# CITY OF SAN ANTONIO

Re: Masterson 335

**MDP # 871**

The City Staff Development Review Committee has reviewed Masterson 335 Master Development Plan **M.D.P. # 871**. Please find enclosed a signed copy for your files. Your plan was accepted however please note the following:

MASTERSON 335  
 MASTER DEVELOPMENT PLAN

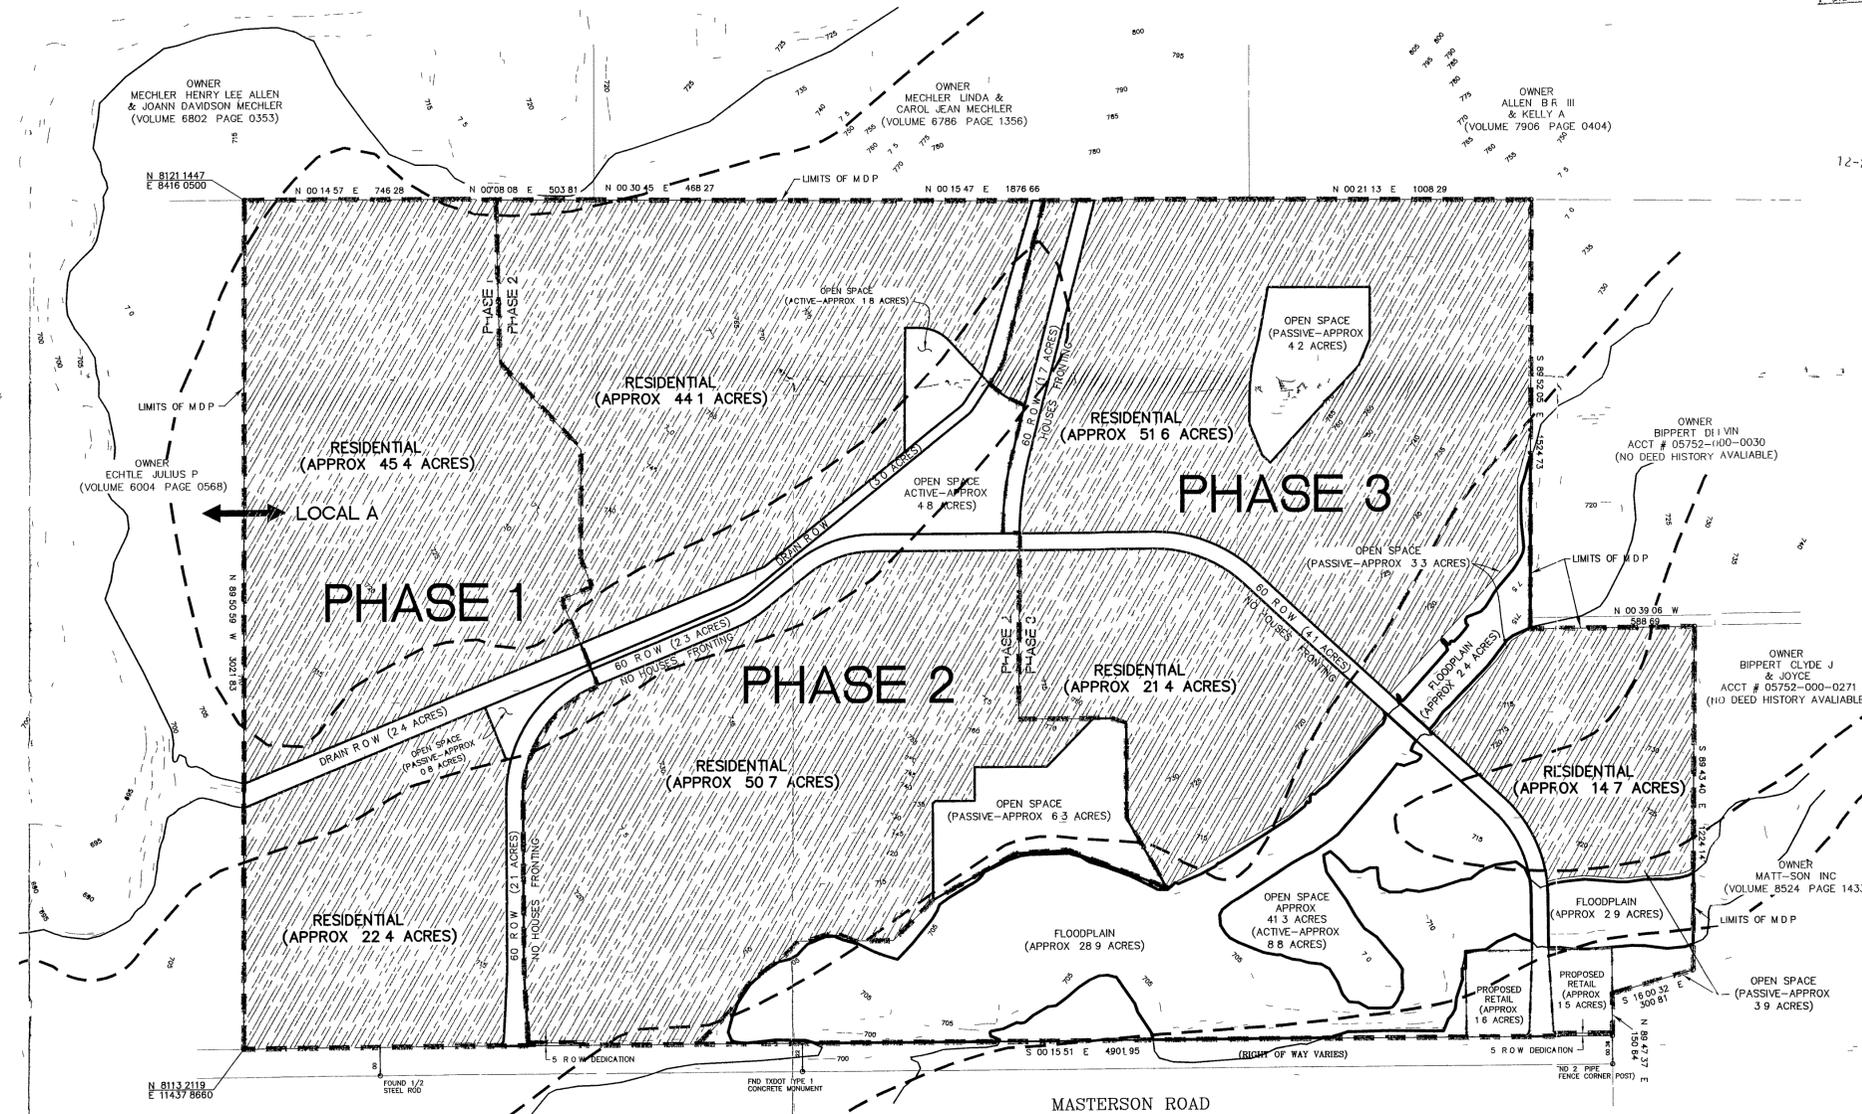
- In consideration of public safety and convenience, excessive grades by reason of topography should be avoided in street layouts and arrangements.
- Any access and R.O.W. issues along state facilities will need to be resolved with the **Texas Department of Transportation (TXDOT)**. For information about these requirements you can contact TXDOT at 615-5814.

- **Master Development Plan/Major Thoroughfare:**
  - Applicant has also stated that a supplemental will be provided as required by UDC §35-506(e)(7). Supplemental needs to show all ingress/egress to the phases from the 60' ROW.

- **Streets & Drainage** states the following issue should be addressed during the respective platting process:
  - The hydraulic calculation of existing and ultimate condition needs cross section plans to contain the water surface elevation within the channel during the submittal of the plats that are next to the floodplain.

- This Master Development Plan will require a Conditional of Letter of Map revision during the platting of the proposed development.
- **DSD – Traffic Impact Analysis & Streets** indicates the following requirements and on-site improvements are necessary and shall be provided by the developer, on and before the completion date of Masterson 335:

- All access roadways shall follow table 506-7, Functional Classification System Description and shall comply with UDC 35-502(a)(9). Additional TIA updates may be required at platting due to no detailed street layout show on the current MDP.

- The developer shall be responsible for providing right-turn deceleration lanes at both entrances off of Masterson, with storage lengths and bay taper as it relates to the submitted TIA traffic counts, (Uniform Development Code (UDC) – 35-502(a)(7), subsection C when traffic volumes warrant.)

- **Bexar County Public Works** has indicated as part of their conditional approval, the following conditions shall be met:
  - An internal loop roadway with no houses fronting will access Masterson Road to the north and the south of the development. Future access to the west and the south into adjacent developments will be provided with projected stub-out streets.
